Technical Information Bulletin

E171

2017 Emissions Retrofit - Emissions Label & Software Campaign

Quantity	Part Number	Description
1	MXENGINELABEL	EPA Label

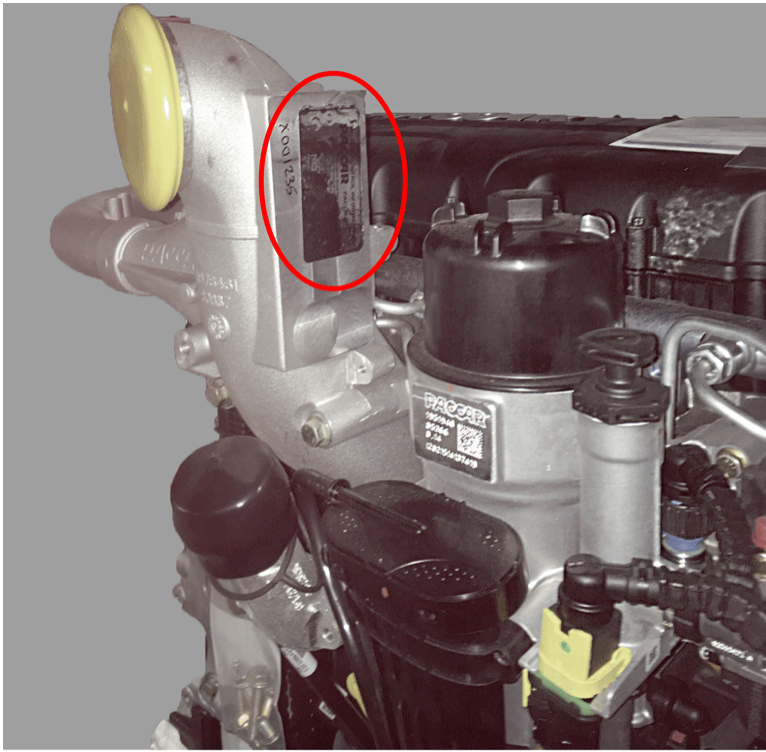
The label currently on the trucks related to this campaign is an exemption label that expired on December 31, 2016.

Parts are available from PACCAR Parts. See Replacement Label [Procedure](#) under Engine Support Center Bulletins.

MX-11

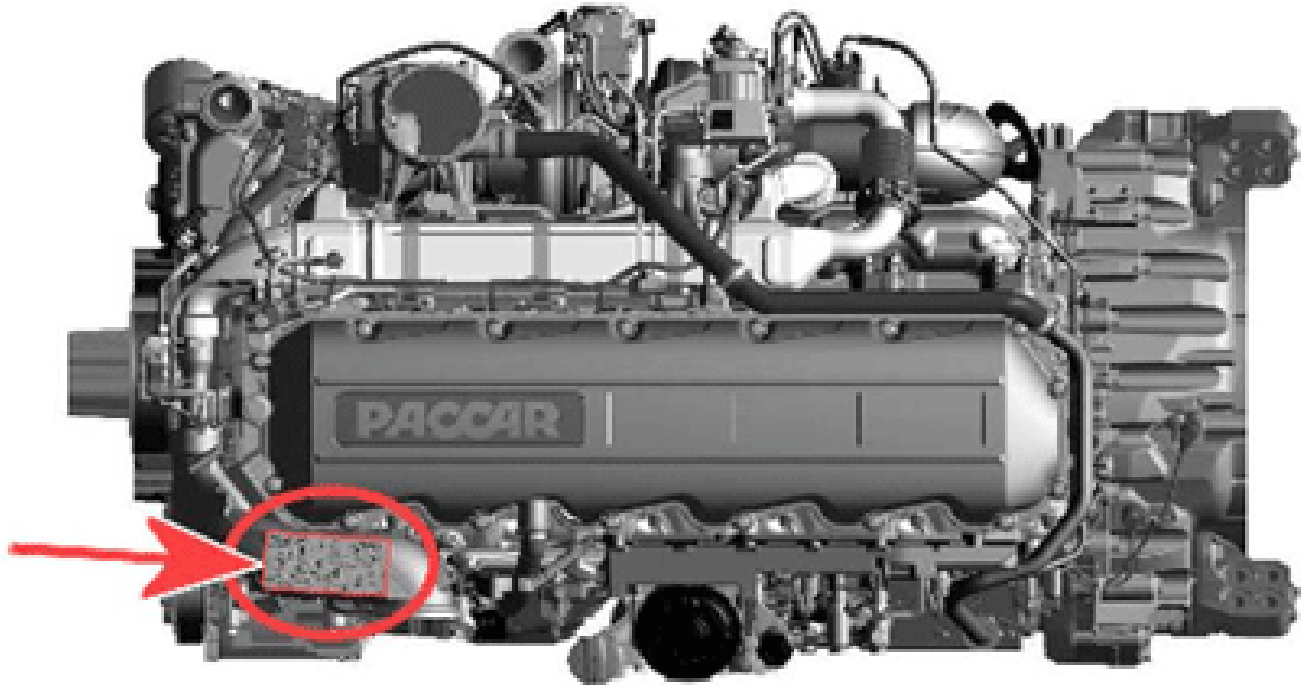
Expiring emissions exemptions for pre-production vehicles must be updated to production levels. This involves engine software and a new emissions label.

See Software Part Number Matrix under [MX-13 GHG2017 \(2017\)](#) and [MX-11 GHG2017 \(2017\)](#).
